AVANI ENVIRONMENTAL INTL. INC. Sales Department 95 Cypress Drive Youngsville, NC 27596 (919) 570-2862 info@avanienvironmental.com	Date	Name	Part Number:	Title:
	2012-02-16	***	***	Booth WB-1066
The drawings, AutoCAD, 3-D Models, and specifications are the property of Avani Environmental Intl. Inc. (AE) and may not be reproduced, distributed, modified, or otherwise used, except provided herein, without the express written permission of AE.	Checked by:		Size	Scale
			A	1 = 25
			Drawing Number:	
			WB-6x6S standard

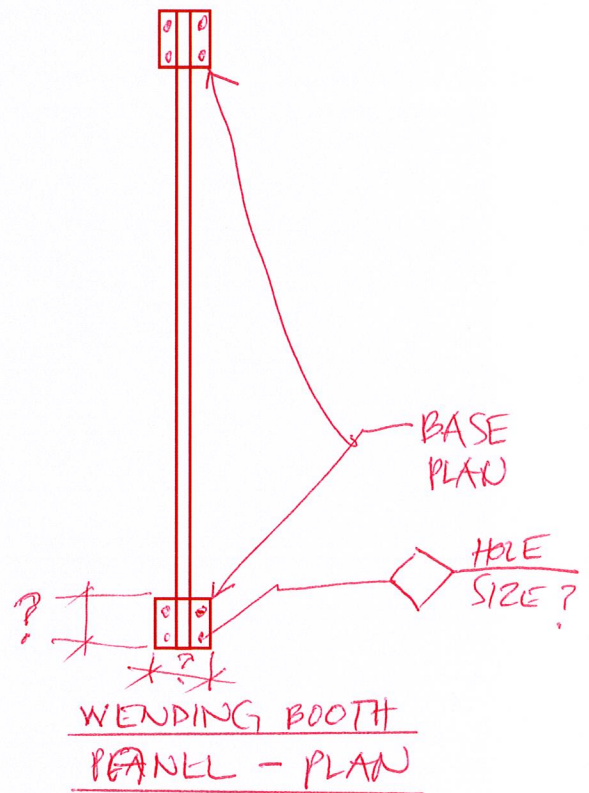
Please provide booth wall panel detail /framing so I can check if I can use this as a ducting support

Please confirm. The base plate of the welding booth panels that I saw at Chevron it seems different with this detail. What I saw has a square base plate with four holes at each end of the panes. I am not sure if this for the bottom or for top connection

This is levelling bolt detail, this is not the panel mounting detail, please confirm

THIS IS THE FUME HOOD SUPPORT, IT CLEARLY SHOWS THAT THERE IS NO DUCT SUPPORT

1. please provide base plate detail.
2. Please provide values with "?"
3. please provide BASE PLATE THICKNESS.
4. BASE PLATE MATERIAL SPECS, ASTM
